Service Bulletin

Number: 777-29-0032

SUBJECT: HYDRAULIC POWER - Main Hydraulic Systems - Nose Landing Gear Alternate
Extension Hydraulic Tube - Change

FIGURE 1: Main Equipment Center - Hydraulic Tube - Access and Change
(SHEET 1 OF 3)

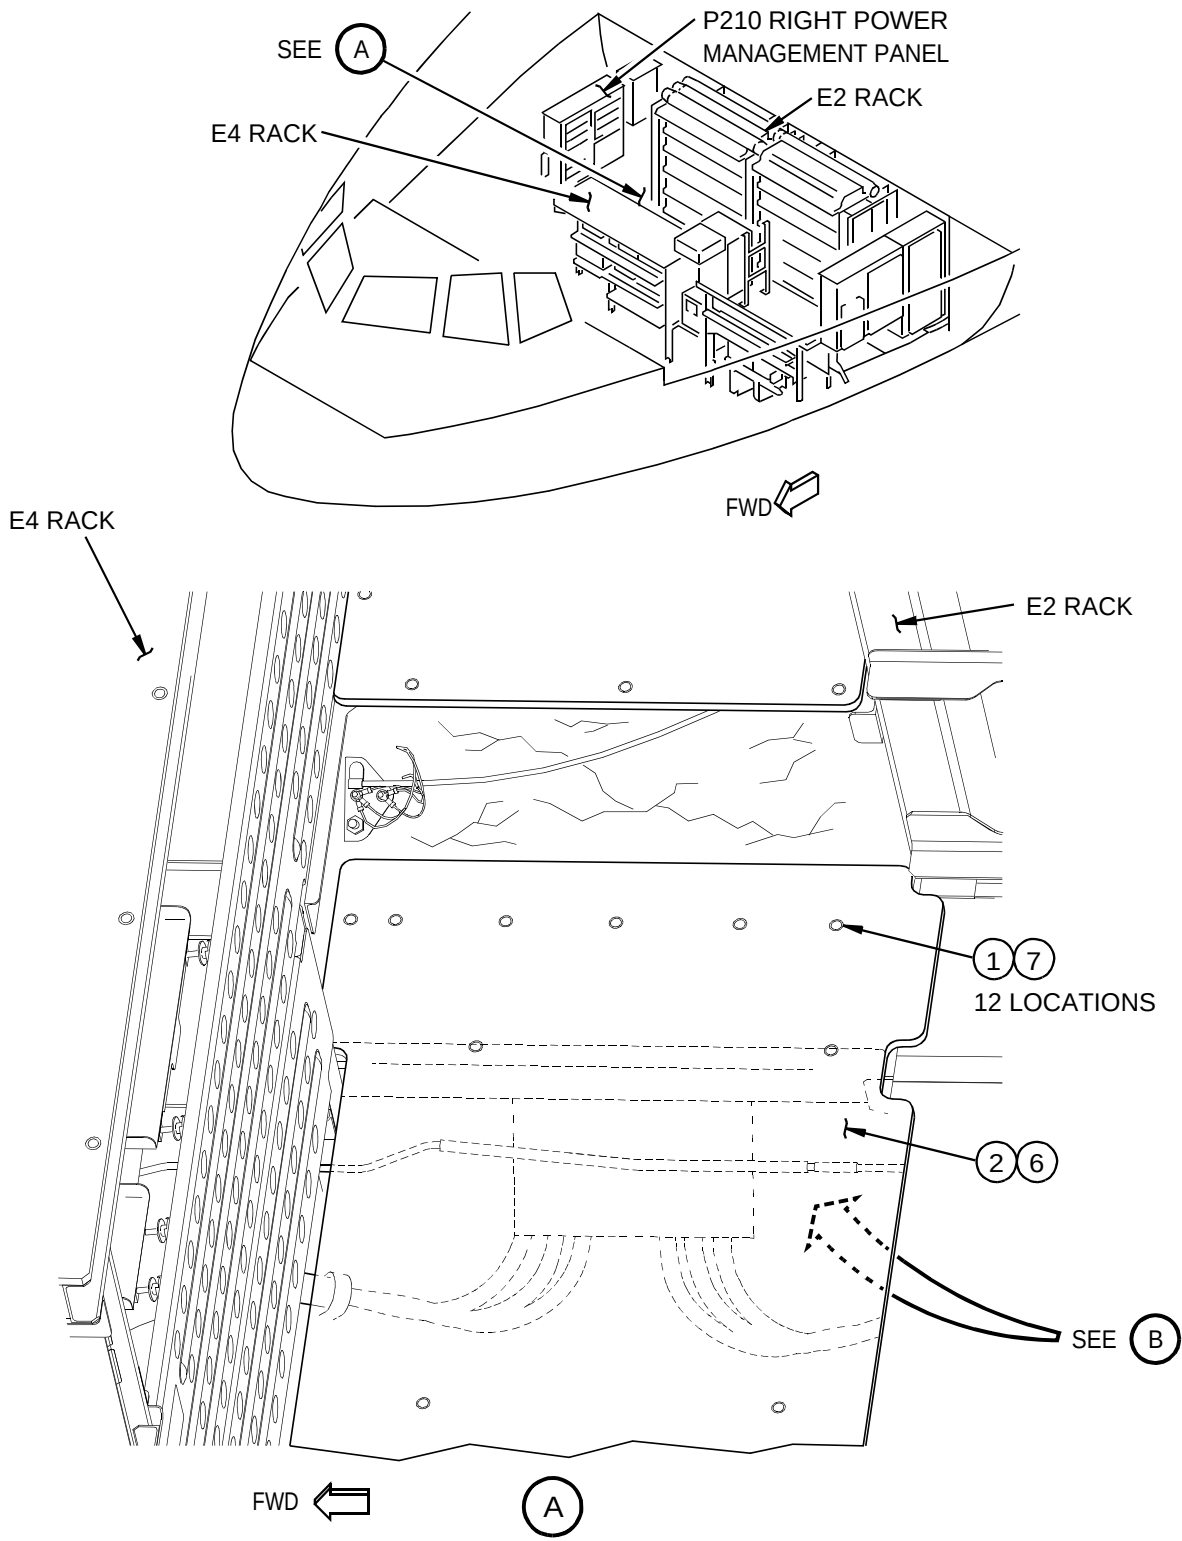
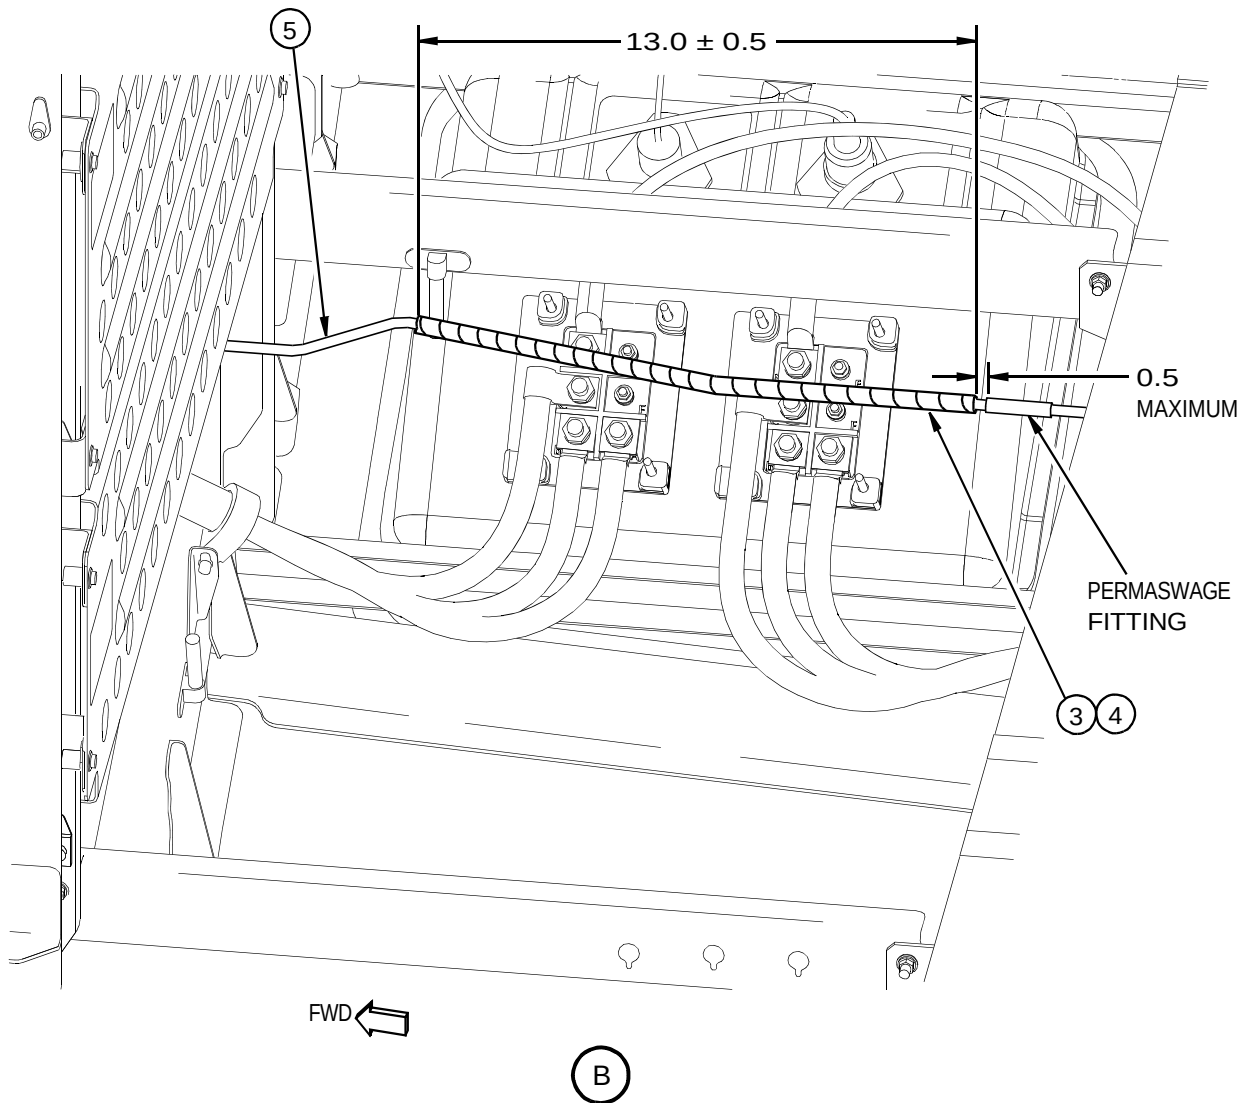
An operator reported a fire in the main equipment center after the maintenance crew connected external power. The cause of the fire was traced to a failure of an external power connector in the P30 panel, which caused high-temperature arcing and splatter of molten copper on an adjacent hydraulic tube. The molten copper splatter created a hole in the tube, and hydraulic fluid sprayed into the power connector and caught on fire.

In the main equipment center, wrap self-fusing fire resistant silicone tape around the section of the nose landing gear alternate extension hydraulic tube that is adjacent to the P30 panel.

STEP	TASK	NAME	IDENTIFICATION	QTY	MORE DATA
1	Remove/Keep	Fasteners	-	12	
2	Remove/Keep	Floor Panel Assy	284W8165-14	1	
3	Clean	Hydraulic Tube	272W4190-93 or 272W4190-168	1	Solvent clean the area where the tape will be installed. Refer to SOPM 20-30-03 as an accepted procedure.
4	Install (New)	Electrical Tape	Scotch 70	-	(a)

STEP	TASK	NAME	IDENTIFICATION	QTY	MORE DATA
5	Apply	Service Bulletin Number	-	-	Apply the service bulletin number to the tube. Do not mark on the Scotch 70 tape. Refer to SOPM 20-50-10 as an accepted procedure.
6	Install (Kept)	Floor Panel Assy	284W8165-14	1	
7	Install (Kept)	Fasteners	-	12	
(a) Wind a continuous length of tape from one end to the other and back again, for a total of two wraps. Make sure that each turn has an overlap of 67% or more. Keep the tension moderate and constant, and stretch the tape between 10 and 100%. Do not stretch the tape when you do the last turn. Push down on the ends of the tape to make sure they do not lift up before the tape fuses.
